**REMARKS**

AMENDMENTS TO THE DRAWINGS

**FIG. 4**

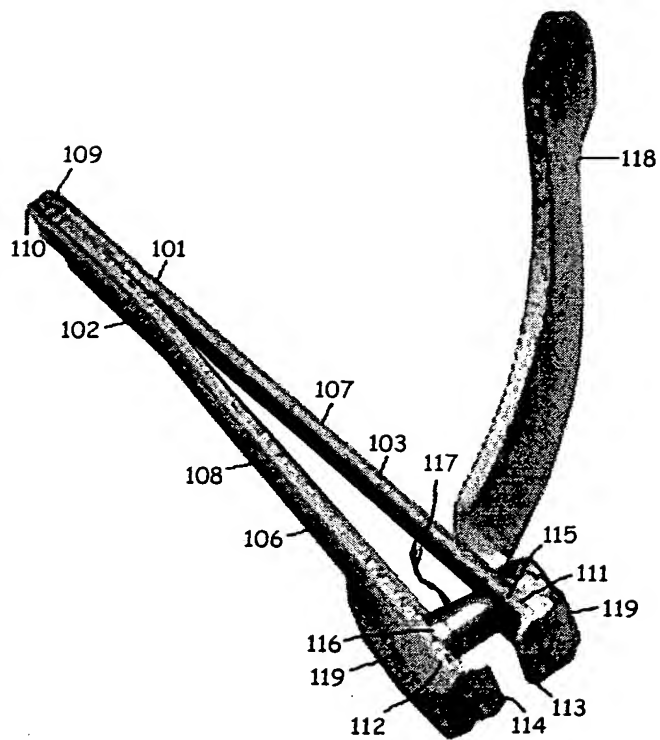
The objection to the drawings is respectfully traversed. It is respectfully pointed that the interconnection between the top and bottom members is shown in Figure 4. As stated on page 3, lines 13-14 of the application, distal ends 109, 110 of the elongated members 101, 102 are interconnected in any convenient fashion. The same figure also shows a post extending from the bottom member 102 to the top member 101. Figure 6 shows a thumb accepting depression 121. With respect to claim 8, the term "offset" was not totally appropriate and more accurately it should have been stated (and the claims have now been amended to state) that the cutting edges are at an angle to the central longitudinal axis of the members. This is shown in Figure 6 and can also be seen Figure 5.

Upon review of the drawings, it has been recognized that the lead line to post 117 in Figure 4 was incomplete, the post was not labeled in Figure 5, and a wrong numeral was used in Figure 6. Corrected drawings are being submitted for entry after approval of the Examiner.

**FIG. 5**

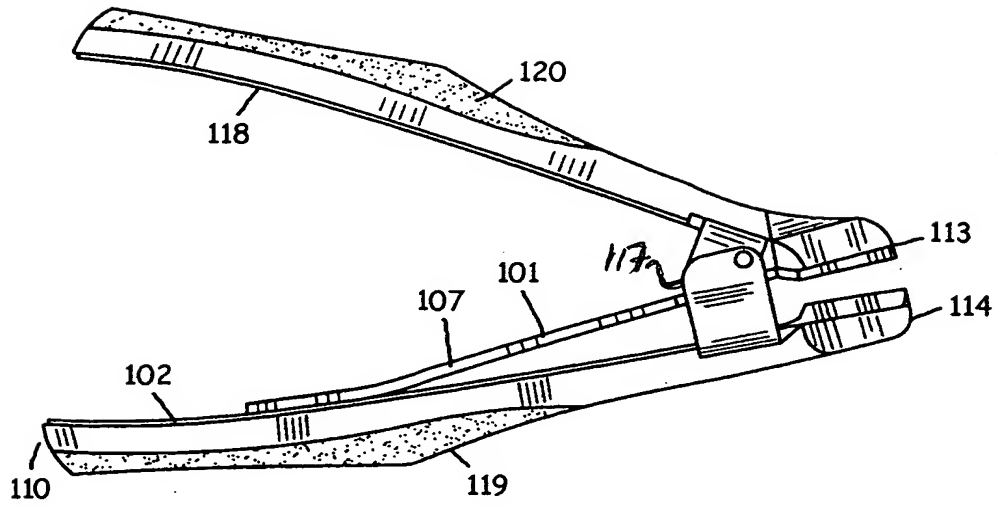
The objection to the specification is respectfully traversed. The structure of the clipper in Figure 5 is clearly described. The top and bottom members are interconnected, albeit not at the distal end as in Figure 4, and there is a post extending from the top surface of the bottom member to above the top surface of the top member, albeit not through an opening in the top member as shown in Figure 4.
